# MEADOWBROOK PARK

## PLANNED UNIT DEVELOPMENT (PUD) AND PRELIMINARY PLAN

# PUD V\_2 review 2 planning only.pdf Markup Summary 4-30-2021

PROJECT NO. 096956009
SHEET  05 OF 10

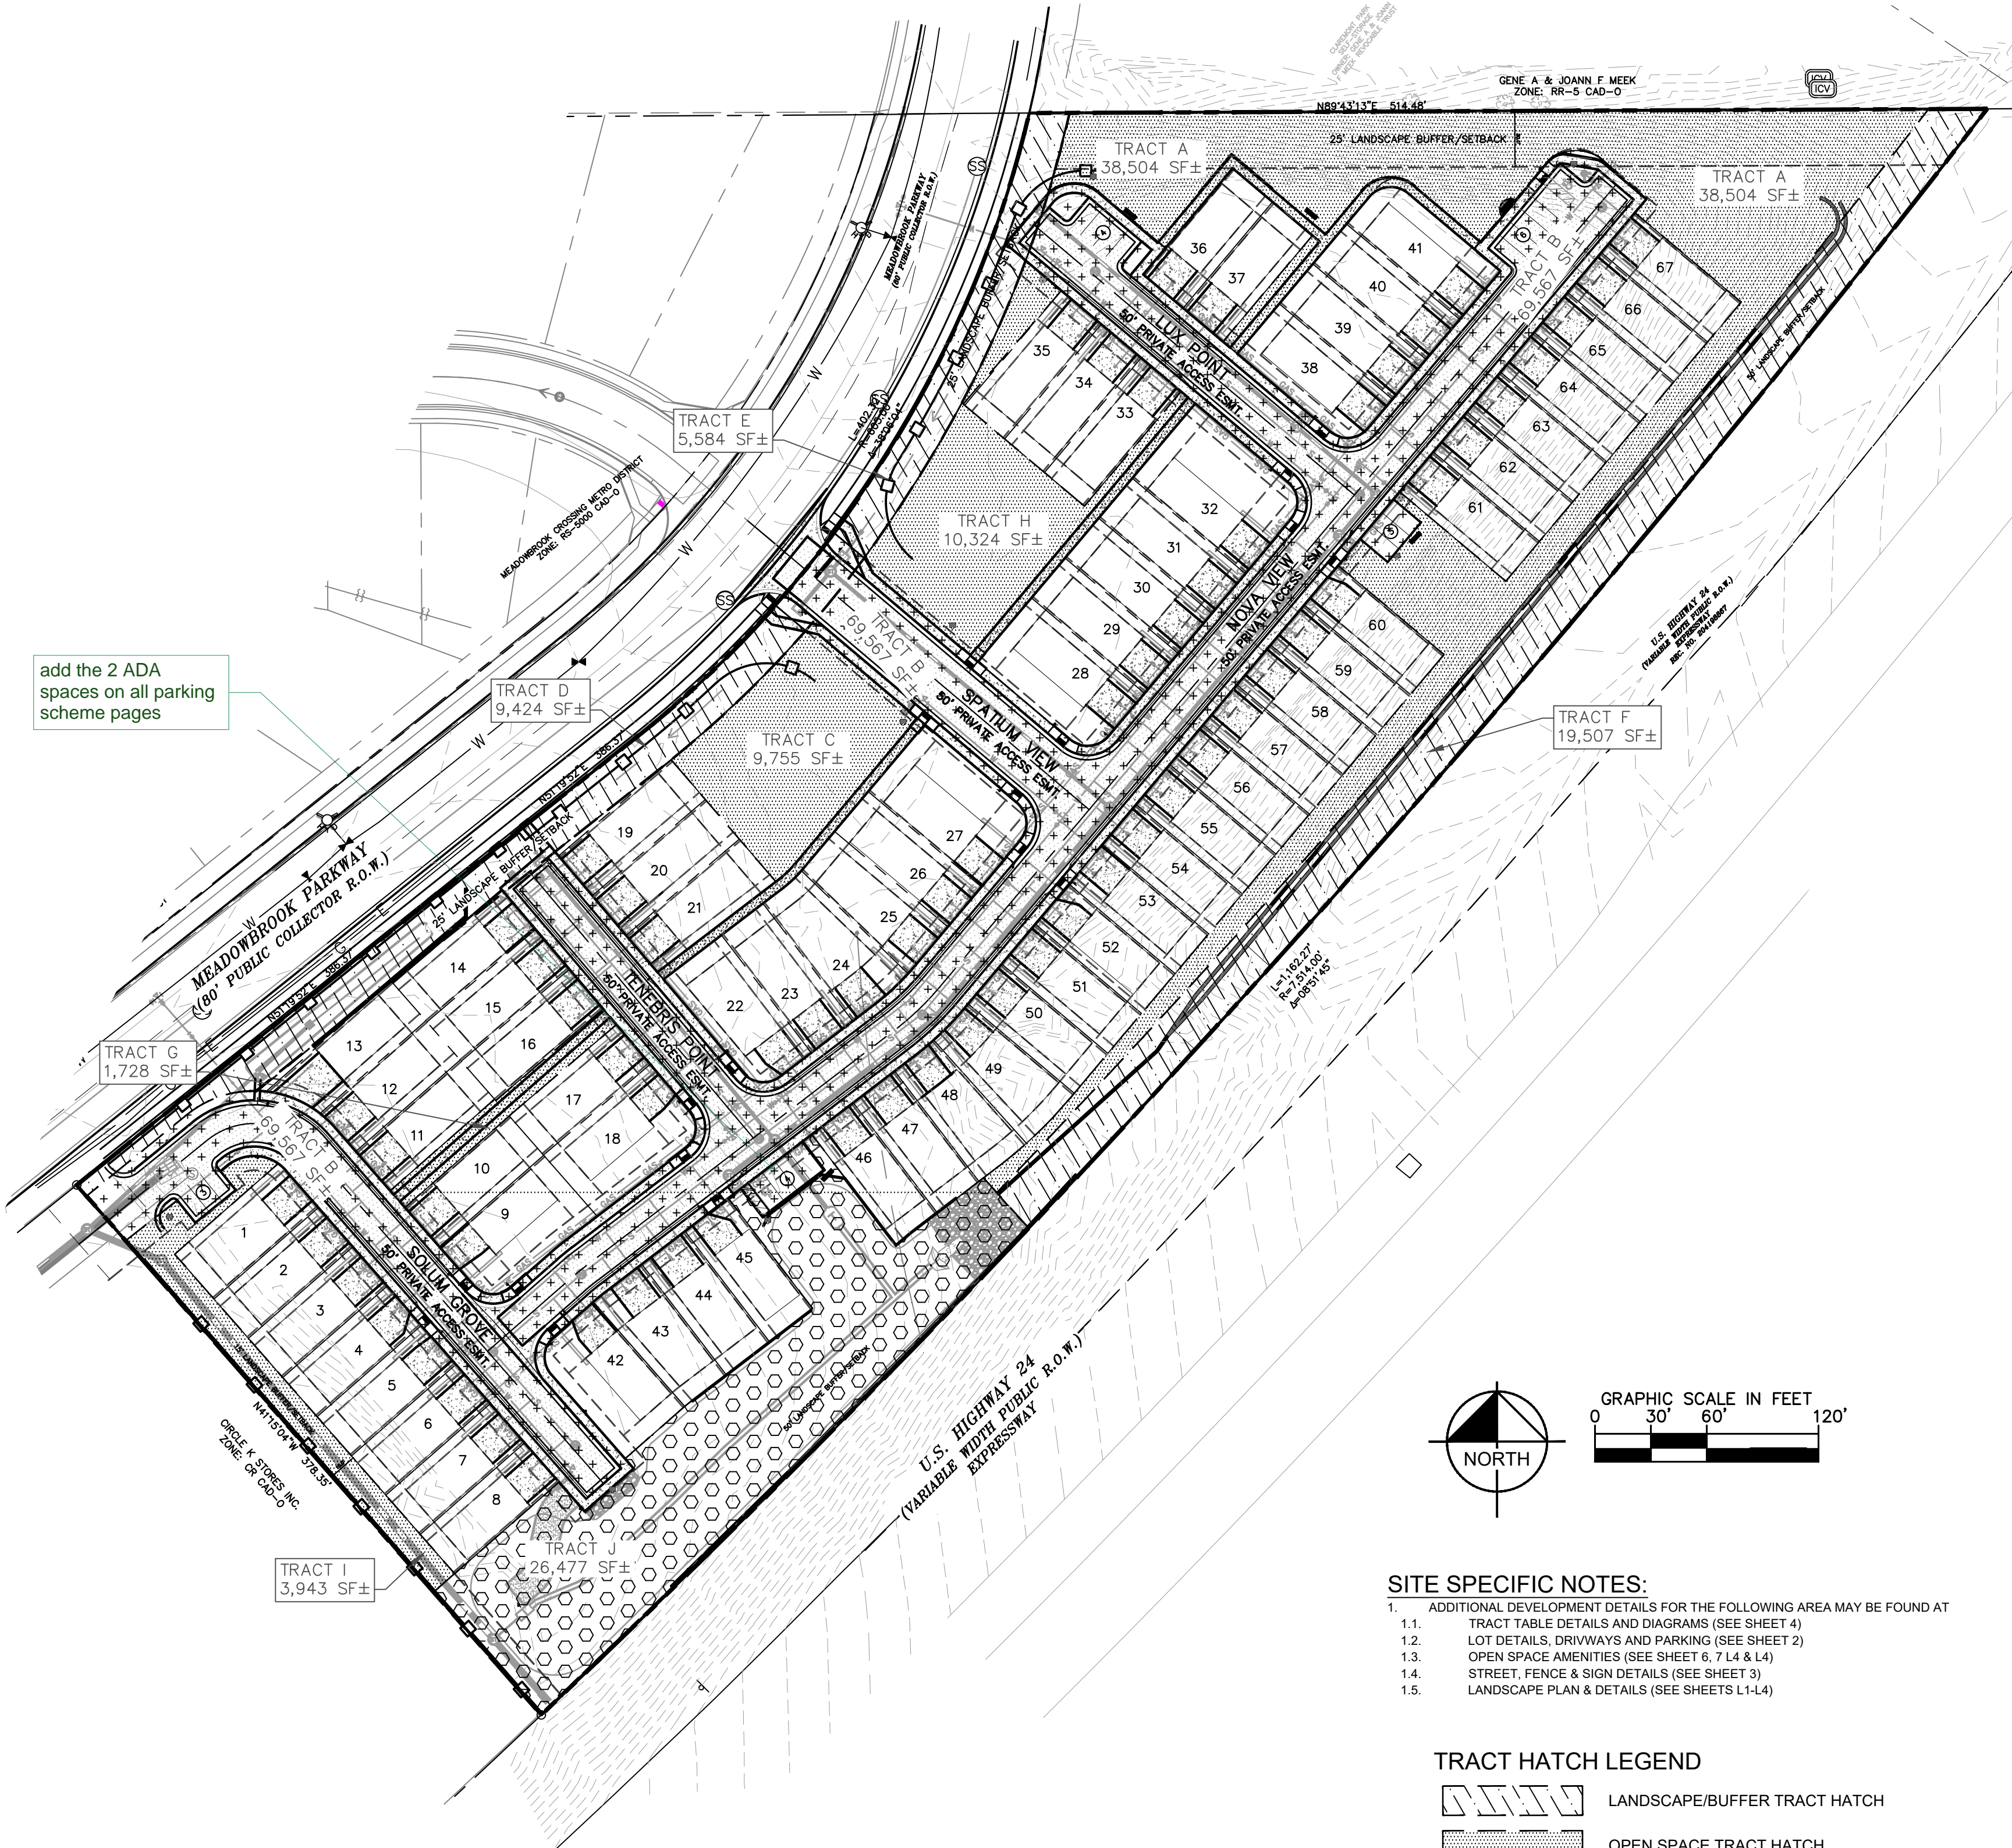
add the 2 ADA spaces on all parking scheme pages
